**Joint Regional Planning Panel
(Sydney East Region)**

JRPP No.	2011SYE112
DA No.:	DA/320/2013 – Demolition of the existing buildings; excavation works and construction of a part 6, part 7 mixed use development comprising ground level retail space, 100 residential units and 3 basement levels of 277 car spaces and associated landscaping works at 84-108 Anzac Parade
Applicant:	Luxcon Group
Report By:	Kerry Kyriacou Manager Development Assessment

Figure 1: Level 10 floor plan indicating void space

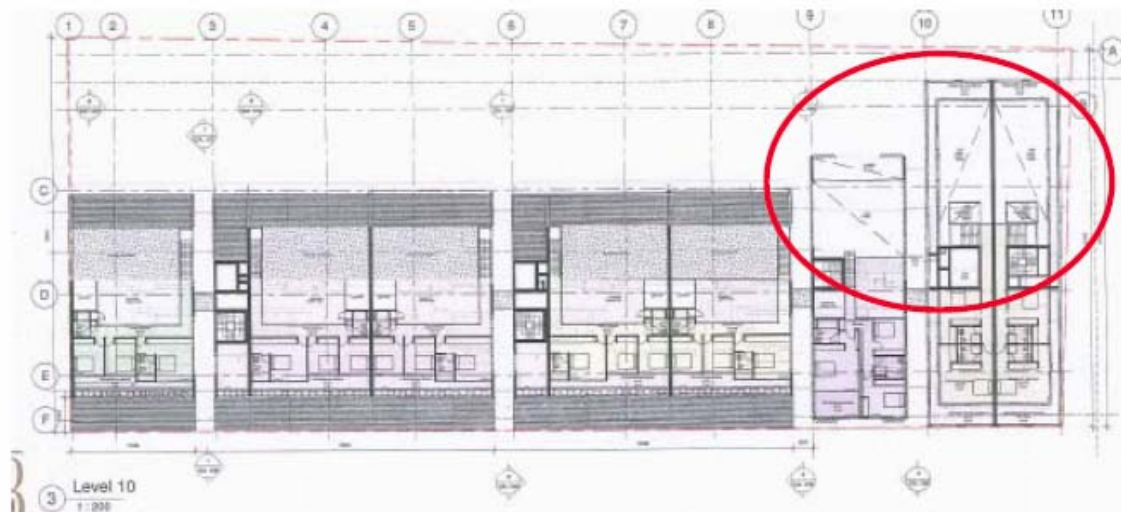
The applicant has reduced the floor area of the upper level to 561m² which is slightly over the 40% limit by 11sqm. The floor area reductions have been made to the rear portions of the upper storey and as such do not meet the intent of the control which only allows the habitable roof space in a recessive form and set back significantly from the street edge. The 7th storey reads as a clear vertical extension of the street wall height at the corner and is not stepped in from the edges of the floor below. The floor area reduction at this level has also been achieved largely through the creation of voids to the south eastern section of the building as indicated in the figure below. Whilst the void provides a 'technical' reduction in floor area, the mass and volume of the building in this location remains the same as that previously considered by the Panel.

Figure 4: Area of height breach

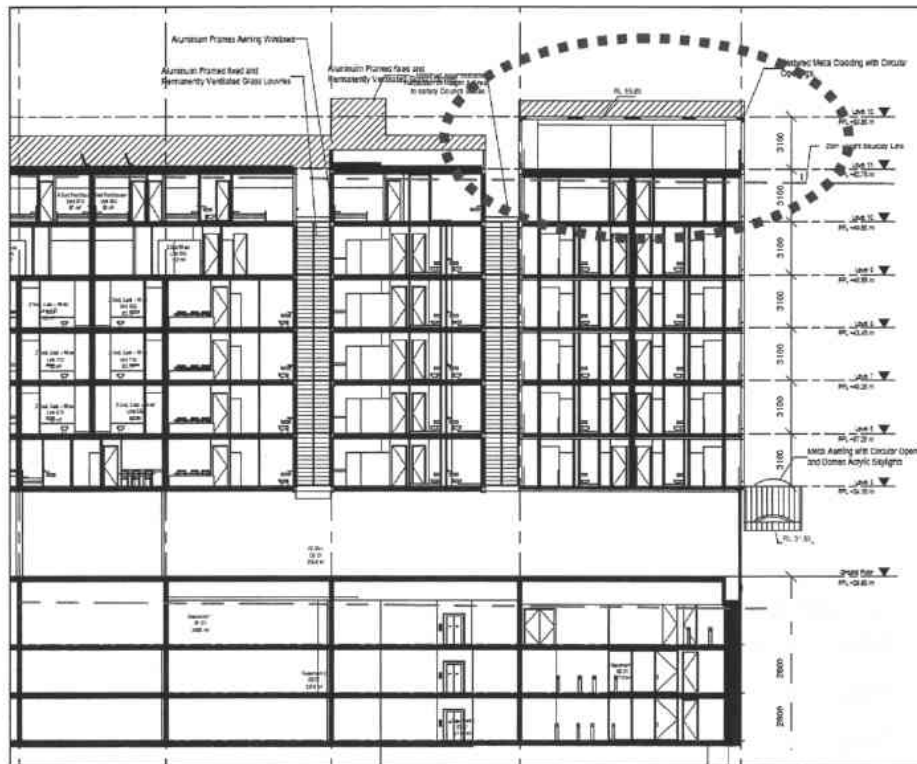
The proposed amendments to the building still result in a breach of the maximum height standard of 25m. The amended proposal has a maximum height of 28.71m. The breach largely occurs at the southern end of the building where it's compounded by the massing of the corner element. The applicant has submitted a request for an exception to the height standard.

Figure 5 : Reduced floor area at level 9

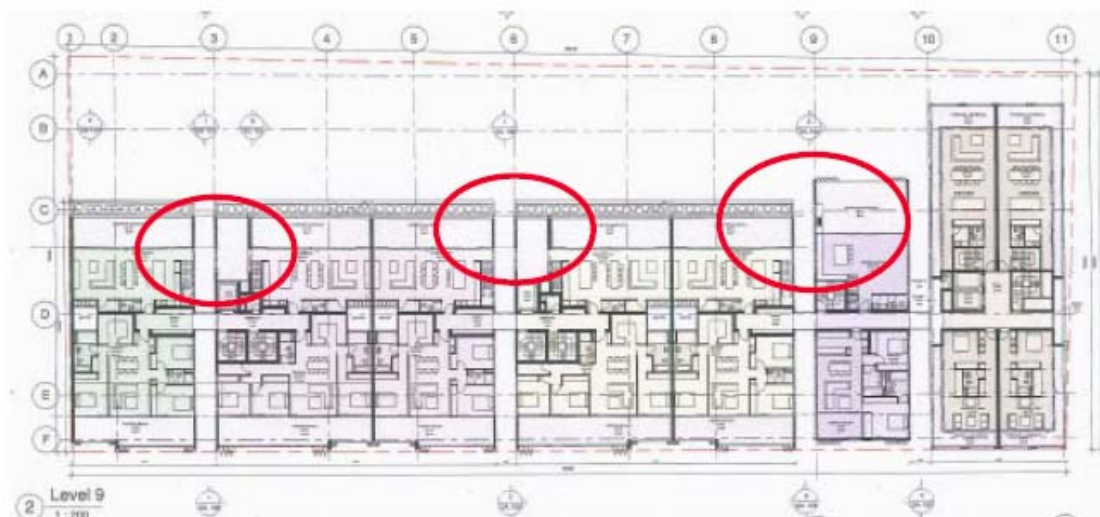
The applicant has indicated in the floor space calculations that there has been a reduction in the floor areas over levels 5 – 9. Council has reviewed the floor plans of each level and it would appear that there have been no changes to the configuration of dwellings or associated floor areas at levels 5 – 8. The only changes in floor area have occurred at level 9 (figure 5) where some of the habitable floor space has been converted to balcony space. This has occurred at the rear of this level and as such there is no reduction in the massing of the building where viewed from the street.

It would also appear that the applicant has not included any internal walls and excluded a number of "winter gardens" that are enclosed and constitute floor area under the definition. Based on Council's calculation, the floor area of levels 5 – 9 equates to 93% of the envelope. Should the "winter gardens" be opened up in a manner that does not constitute floor area the proposal would still comprise 89% of the envelope.
